**DATE:** 01.03.2018  
**TO:** ProTrak  
**FROM:** Mitesh Baxi  
Traffic Engineering

■ **WOODLANDS AT ECHO FARMS TRACT 2 [TRC Plan Review]**

∞ Initial Review Note ∞

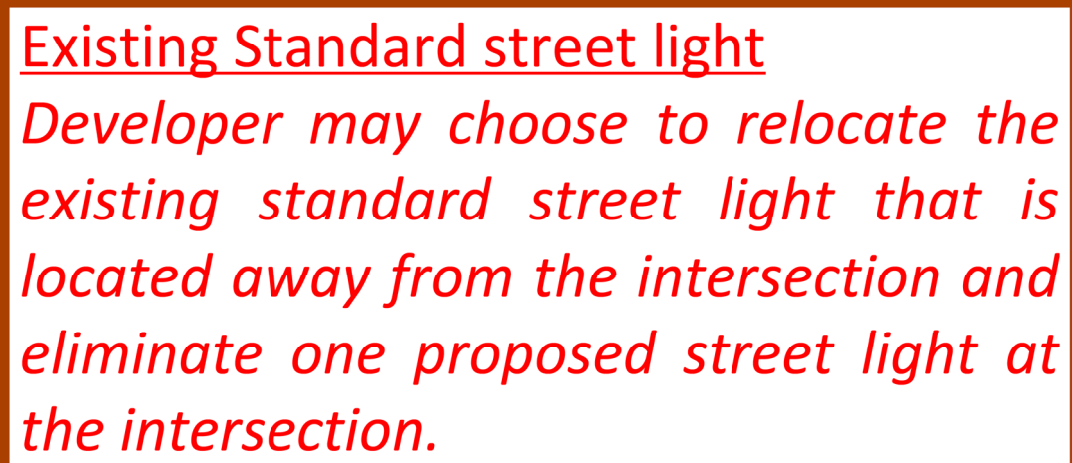
1. Please specify appropriately whether a section of Road to access units 25 to 30 will be designated as public ROW or private ROW.
2. The T-shaped turnaround off Road R must be as per [SD 3-05](#). Dimension the radii accordingly.
3. The wheel chair ramps shown at the intersections with Independence Blv are not installed as per [SD 3-09](#). The ramps at marked crossings must be wholly contained within the markings.
4. Install wheelchair ramp at corner of 22' wide backing stub, at the entrance of proposed parking area, opposite of units 47 & 48', at the entrance of proposed parking area, and at the end of T-shaped turnaround as per NCDOT and/or City standards. Connect sidewalk with ramp.
5. The minimum street corner radii is 35'. [\[7-5 CofW Tech Stds\]](#) Please amend wherever applicable on site plan.

6. The sight distance triangle for the street corner intersection is not as per City standard. Show and apply the City's 46'x46' sight distance triangle at each street corner intersection on the site plan. [\[Sec.18-529\(c\)\(3\)CofW LDC\]](#) Add a note indicating that all proposed vegetation within sight triangles shall not interfere with clear visual sight lines from 30"-10'. [\[Sec.18-556 CofW LDC\]](#) Also show and apply the City's 20'x70' sight distance triangle at the driveway for the proposed parking area.

7. Parking lot must meet requirements of standard details [SD 15-11 CofW Tech Stds](#) for parking lots under 25 stalls. Please amend the driveway width to 24' and design as per [Chapter VII, Detail 3-03.1 & 3-03.2 CofWTSSM](#).
8. Twenty-four feet (24') is the minimum drive aisle width behind perpendicular parking. [\[Table 6, page 7-19 CofWTSSM\]](#)
9. The backing stub is to be 10' deep by 15' wide. Please revise and dimension. [\[Chapter VII, Detail SD 15-12 CofWTSSM\]](#)

**Woodlands At Echo Farms Tract 2 Standard Street Lighting Plan**

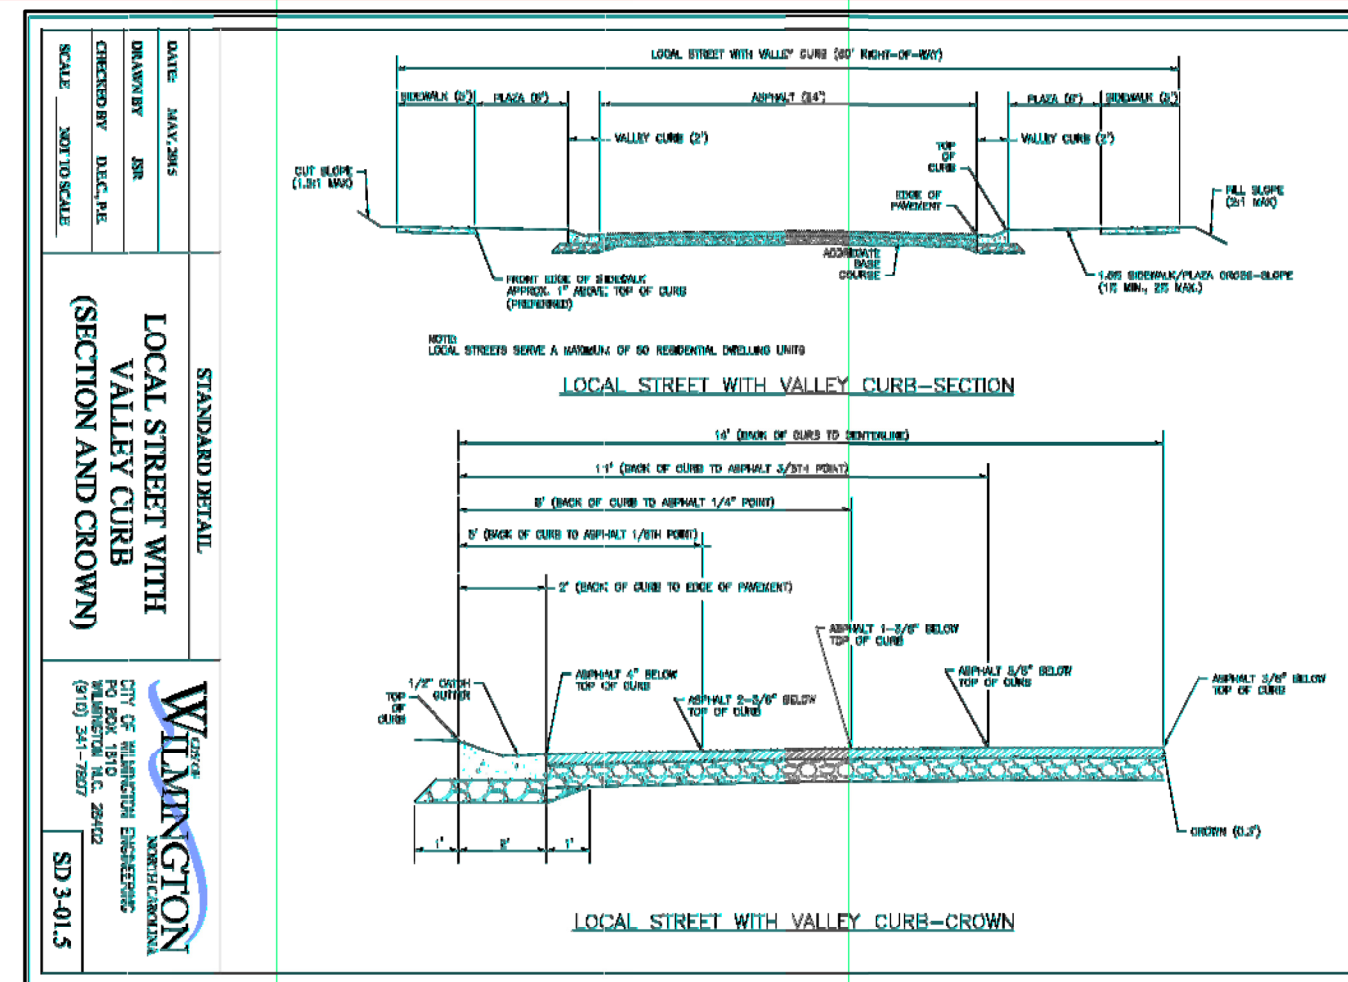
10. The street lighting plan is prepared assuming turnaround access for units 25 to 30 as a public ROW. Street lighting plan will be amended if the scenario changes.

12. A layout for the Standard street lighting has been provided with the review considering all Roads for this site as public ROW. Minimum of 10 (Ten) street lights are required for this sub-division. Although, developers may choose to provide any extra lights or ornamental. Any installations above the criteria of Standard street lighting, will be considered as non-standard and has to conform to the City's non-standard street lighting procedure as per the policy.

Assuming turnaround access for units 25 to 30 will be a public ROW, suggested approximate locations of minimum required 10 street lights. Locations may vary as per the field survey by DEP.
